3.0 RESPONSE TO COMMENTS

Re: Notice of Availability of a Draft
Environmental Impact Report
for the Avenue Specific Plan

RE: Draft Environmental Impact Report for The Avenue Specific Plan

Exhibit 1.1: Major System-Wide Transit Corridors

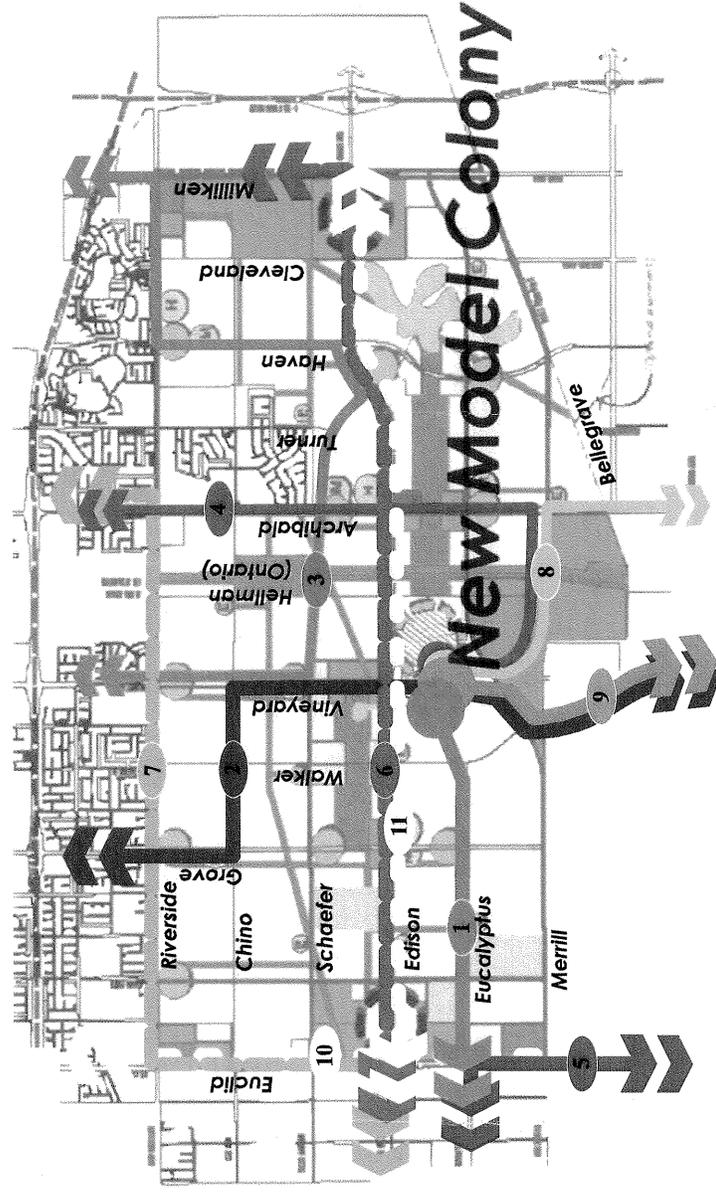
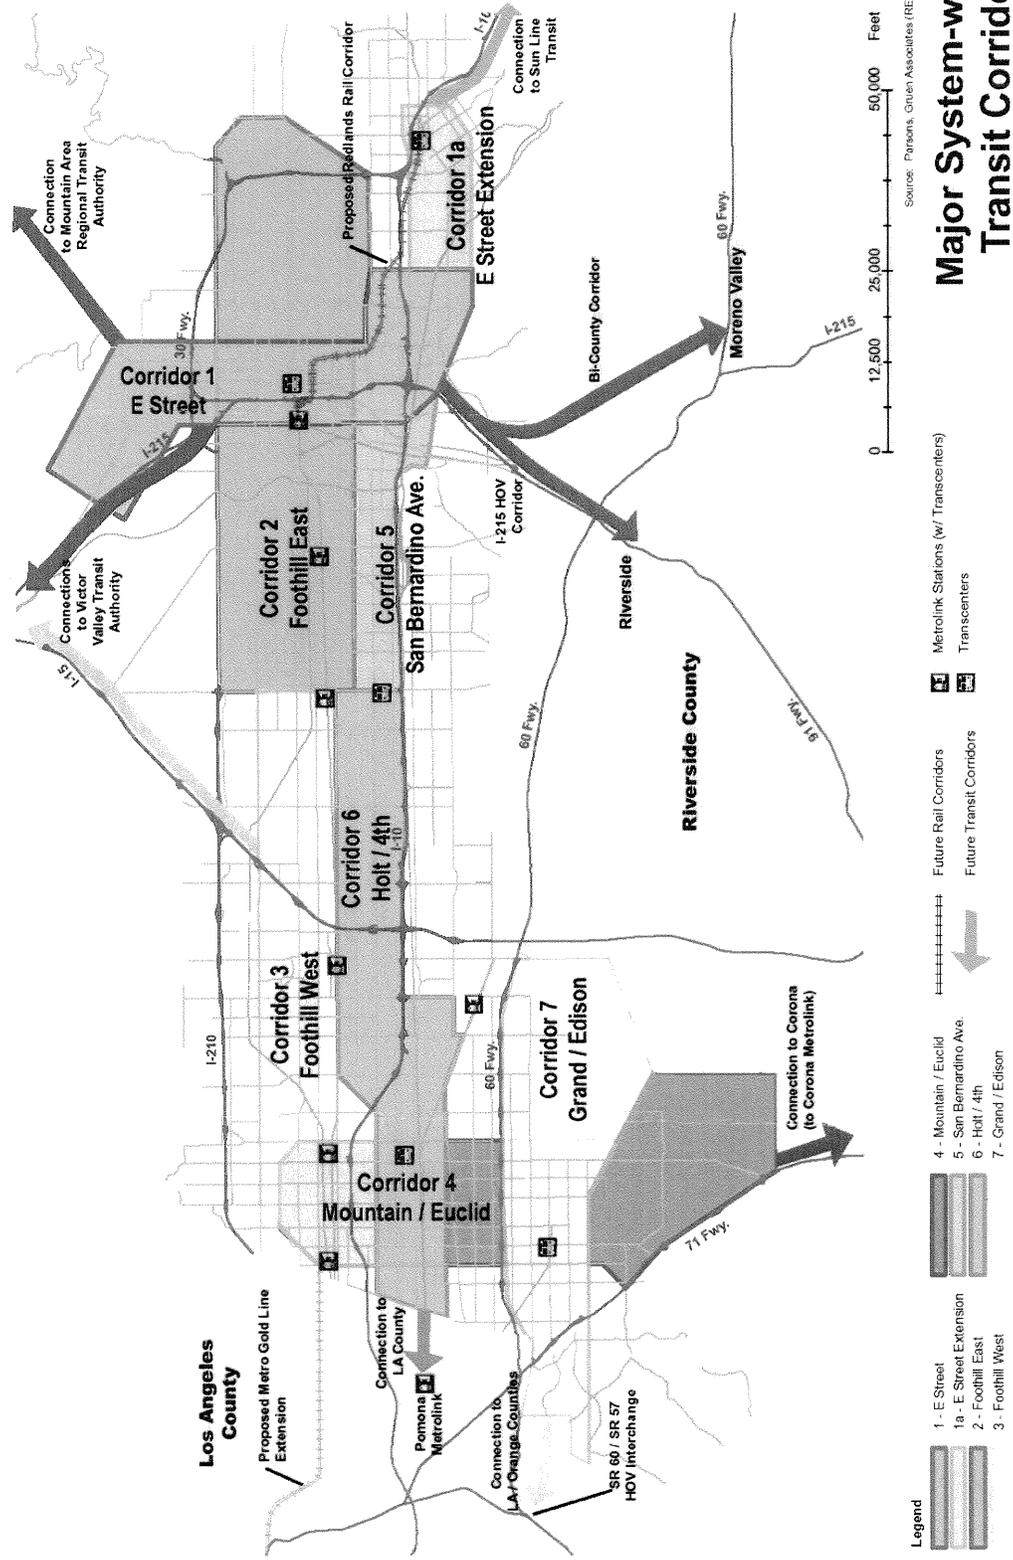
Currently, Omnitrans does not operate fixed route service or Access service (ADA mandated demand response service for persons with disabilities) in the specific plan area. Several studies have been undertaken to identify future routes in this area which include *The Chino-Ontario Community Based Transportation Plan, July 2005* and the *System-Wide Transit Corridor Plan for the San Bernardino Valley, September 2004*. Both documents identify Edison Avenue as a Bus Rapid Transit (BRT) corridor. In addition, Haven Avenue will have transit service in the future. Maps from both documents have been enclosed for your review.

The City acknowledges Omnitrans as the public transportation provider and thanks Omnitrans for the information regarding future transit service in the New Model Colony.
